GW - 082

**RE: Inspection Report Follow-up, GW-082
Chevron USA Inc. Lateral #1 Compressor Station
Rio Arriba County, New Mexico**

**Re: Inspection Report, GW-082
Chevron, Lateral # 1 Compressor Station
Rio Arriba County, New Mexico**

OCD Inspection Chevron Lat # 1, GW - 082

Figure 1

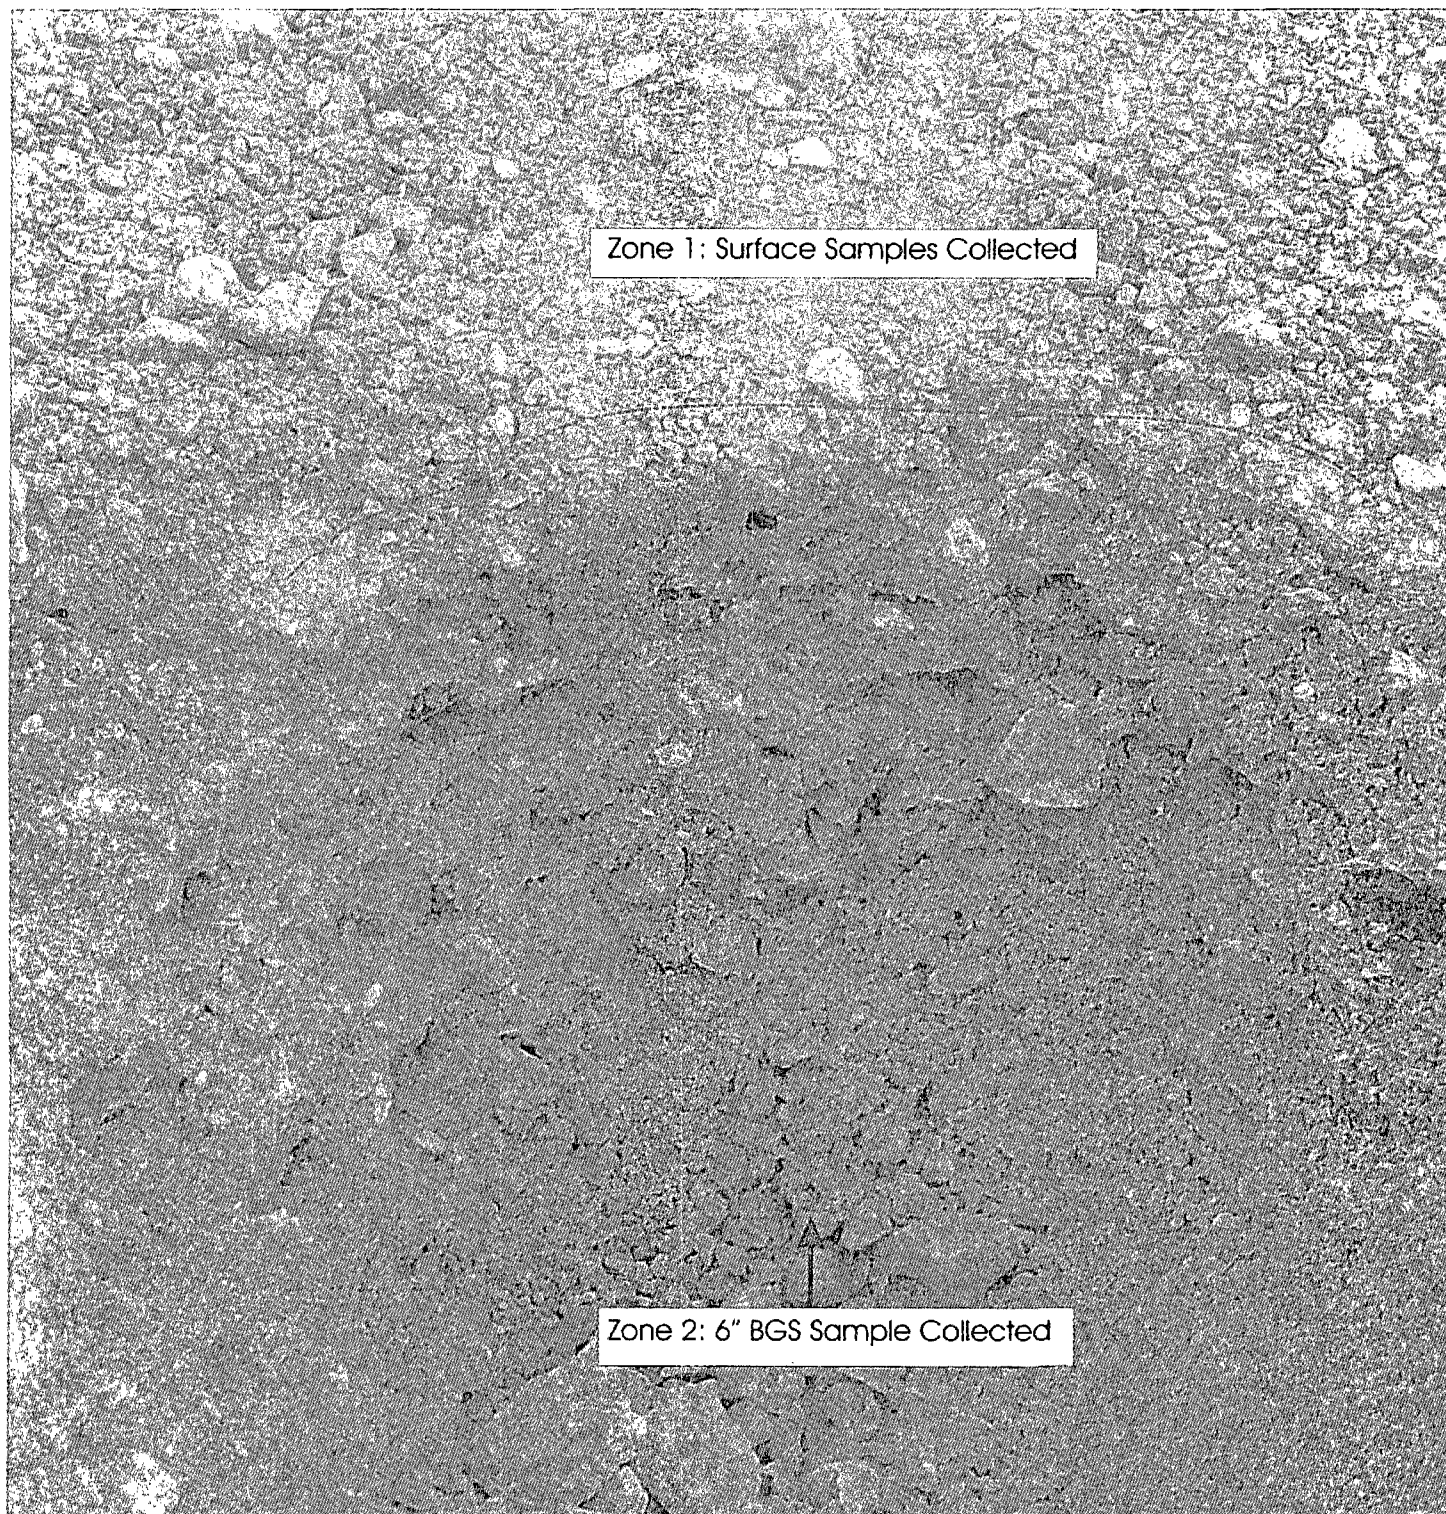
Because compressor oil spilled on the south end of the compressor during removal, and because visual contamination was observed on the south-west corner; see enclosed *Site Photography*, the sample location was divided into two (2) areas. At this time, three (3) additional samples were collected from the spill areas. One (1) five (5)-point composite sample was collected from the surface of Area 2, one (1) five (5)-point composite sample was collected from the surface of Area 1, and one (1) sample was collected from 6" below ground surface (BGS) in Area 1. The samples were analyzed in the field for TPH using USEPA Method 418.1 and for organic vapors using a PID. Each of the three (3) samples was below the regulatory limit of 100 ppm organic vapors. The sample collected from 6" BGS in Area 1 was below the regulatory limit of 1,000 ppm TPH; however, the samples collected from the surface in Areas 1 and 2 were above the regulatory limit of 1,000 ppm TPH at 11,600 ppm and 4,080 ppm respectively; see enclosed *Analytical Results*.

Area of Discoloration Underlined.

Envirotech, Inc. recommends either additional excavation of the surface and sampling activities be conducted, or the area be treated on site with potassium permanganate/urea nitrate to aid with natural attenuation.

Photo 1: Catch pan installed on shortened load line.

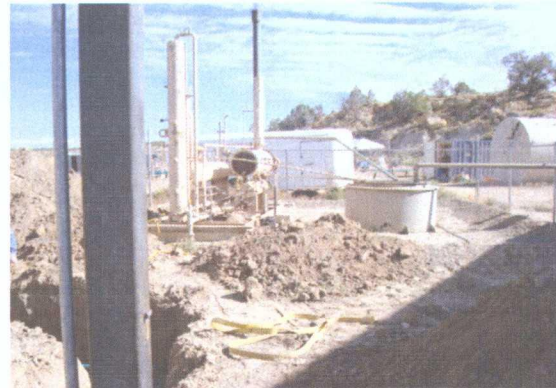
Finding	Description (Inspection Report May 7, 2008)	Action
1	<i>Catch pan needed for pipe to prevent discharge on to ground. Chevron needs to address issue within 3 months.</i>	Photo 1: Load line was shortened to within bermed area and a catch pan was installed. Photo 2: Catch pan installed.
2	<i>BGT needs to be removed and replaced with one that has a leak detection system. Chevron has 3 months to address issue.</i>	Photo 3: BGT has not been removed but has been taken out of service. A replacement tank is currently being installed as described in the Chevron GW 082 Lateral #1 Compressor

Photo 6: No unlabeled containers on location.

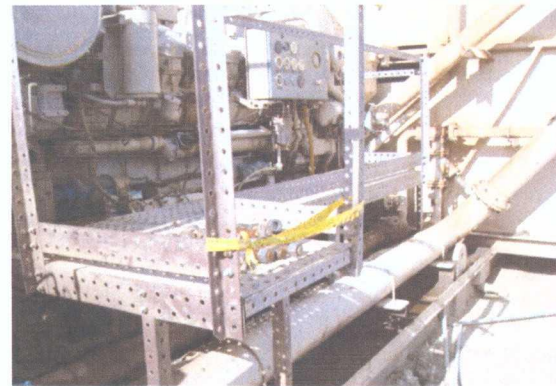
6	<i>Unidentified/unlabeled container near engine. Chevron shall ensure that all liquids are identified and stored properly within permit conditions.</i>	Photo 6: No unlabeled containers are on location.
7	<i>Berm the facility to decrease run on and off of water. This will prevent erosion; the possibility of any spills or releases from going off site and creating excess waste from run on commingling with liquids on site.</i>	The facility will be bermed upon completion of the Lateral 1 compressor modification project. Photos will then be provided. ✓
8	<i>Perform hydrostatic testing of all underground piping, if they have not been performed. Submit results to the OCD when completed. Review permit conditions for testing specifics.</i>	Hydrostatic testing will be performed when new underground piping has been installed. The results will be submitted to OCD as requested. ✓

Photo 1: Catch pan needed on line.

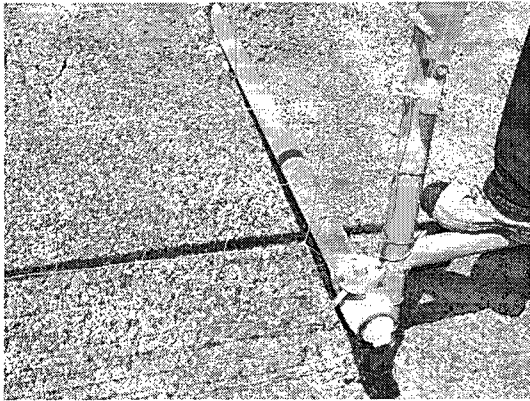
1. Photo 1 & 2: Catch pan needed for pipe to prevent discharge on to ground. Chevron needs to address issue within **3 months**.
2. Photo 3 & 4: BGT needs to be removed and replaced with one that has a leak detection system. Chevron has **3 months** to address issue.

Photo 4: Lines going in to BGT.

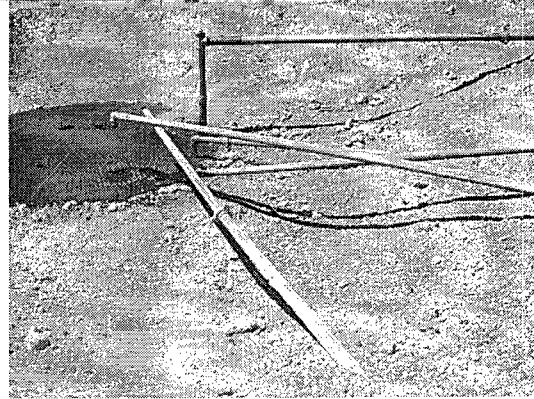
Photo 3: Double bottom, covered singled wall BGT needs to be replace.

Photo 5: Idle liquids with staining on ground.

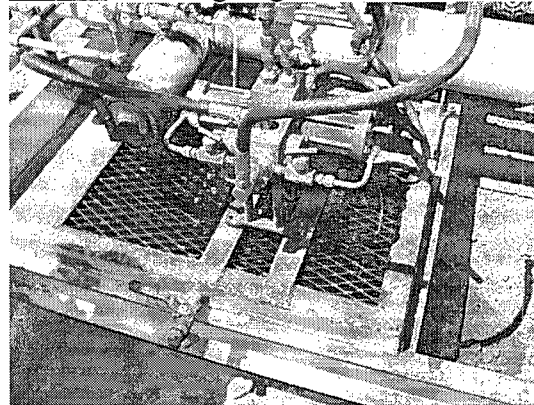
3. Photo 5: Liquids are not allowed to stay in secondary containments more than 72 hours. Chevron shall properly remove liquids within sufficient time.

Station Modification Request (dated 08/15/2008) and e-mail correspondence (08/19/2008) between Leonard Lowe and Suzanne Shore.
3	<i>Liquids are not allowed to stay in secondary containments more than 72 hours. Chevron shall properly remove liquids within sufficient time.</i>	Reviewed requirements with personnel and liquids will be removed within sufficient time.
4	<i>Berms appear to be eroded and needed to be addressed. Chevron needs to resolve this issue within 3 months.</i>	Photo 4: Chevron is currently digging in the area of this unit to install piping as part of compressor modification effort. Photos of the repaired berm will be provided upon completion of the project. ✓
5	<i>The secondary containment galvanize tank appears to have an integrity breach. Chevron needs to repair or replace containment. Any discharge of fluids on to the ground needs to be properly cleaned. Chevron shall address within 3 months.</i>	Photo 5: The secondary containment of galvanized tank has been replaced.

Photo 6: Berms seemed to be eroded.

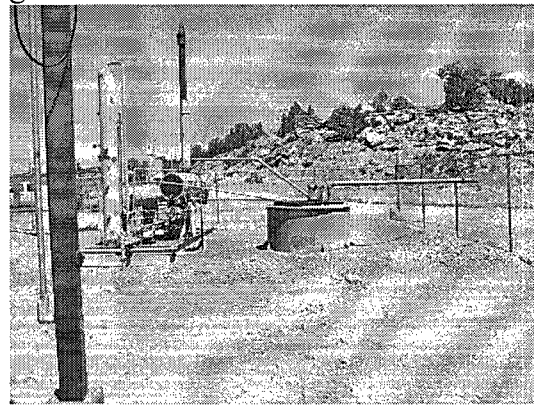
4. Photo 6: Berms appear to be eroded and needed to be addressed. Chevron needs to resolve this issue within **3 months**.
5. Photo 7: The secondary containment galvanize tank appears to have an integrity breach. Chevron needs to repair or replace containment. Any discharge of fluids on to the ground needs to be properly cleaned. Chevron shall address within **3 months**.

Photo 8: Unidentified liquid in unlabeled container near engine.

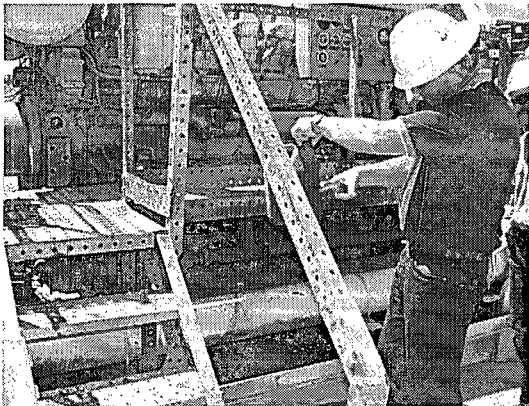
6. Photo 8: Unidentified/unlabeled container near engine. Chevron shall ensure that all liquids are identified and stored properly within permit conditions.
